[Docket No. FAA–2007–28661; Directorate Identifier 2007–NM–013–AD; Amendment 39–16785; AD 2011–18–03]

Airworthiness Directives; The Boeing Company Model 737–600, –700, –700C, –800, and –900 Series Airplanes

ACTION: Final rule.

Figure 1

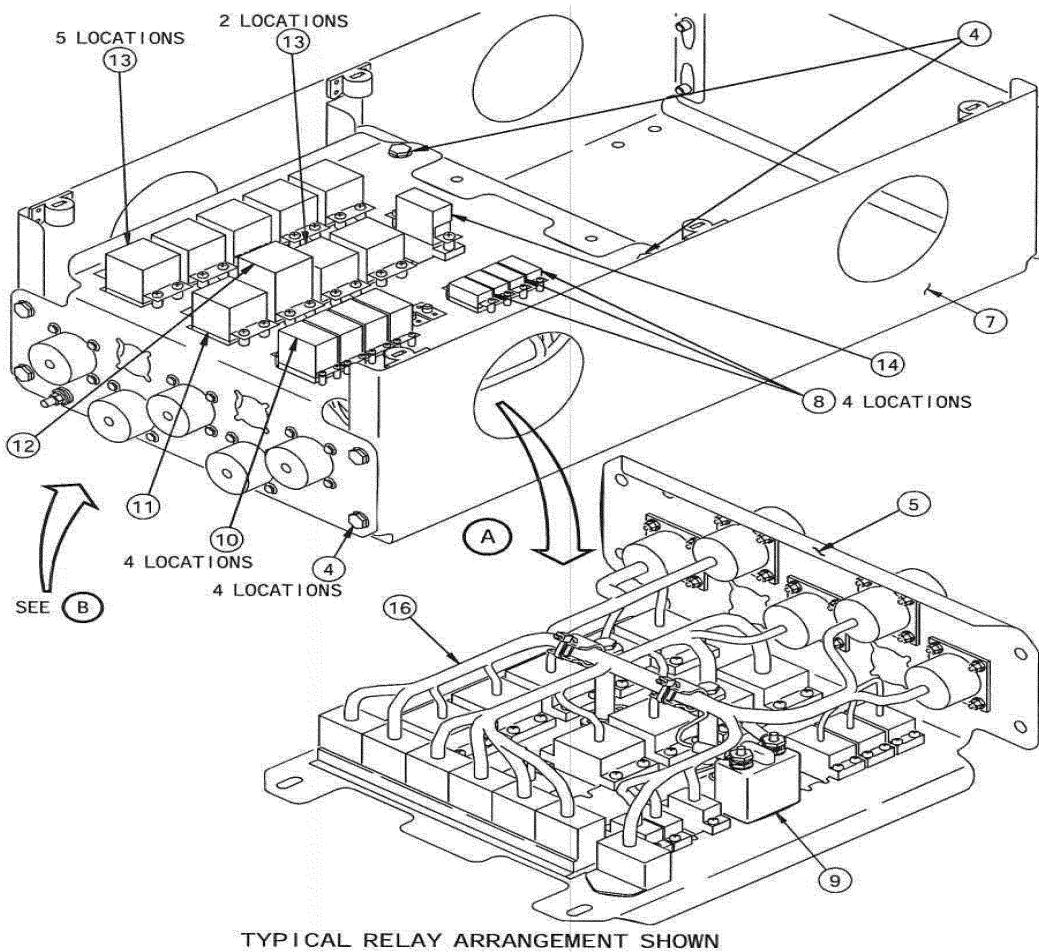
Part 1 and Part 2 of the Accomplishment Instructions of Boeing Alert Service Bulletin 737-28A1206, Revision 2, dated May 21, 2009, except that Figure 1 of this AD must be used in lieu of Sheet 2 of Figure 11 of Boeing Alert Service Bulletin 737-28A1206, Revision 2, dated May 21, 2009. If a placard has been previously installed on the airplane in accordance with paragraph (h) of this AD, the placard may be removed from the flight deck of only that airplane after the automatic shutoff system has been installed. Installing automatic shutoff systems on all airplanes in an operator's fleet, in accordance with this
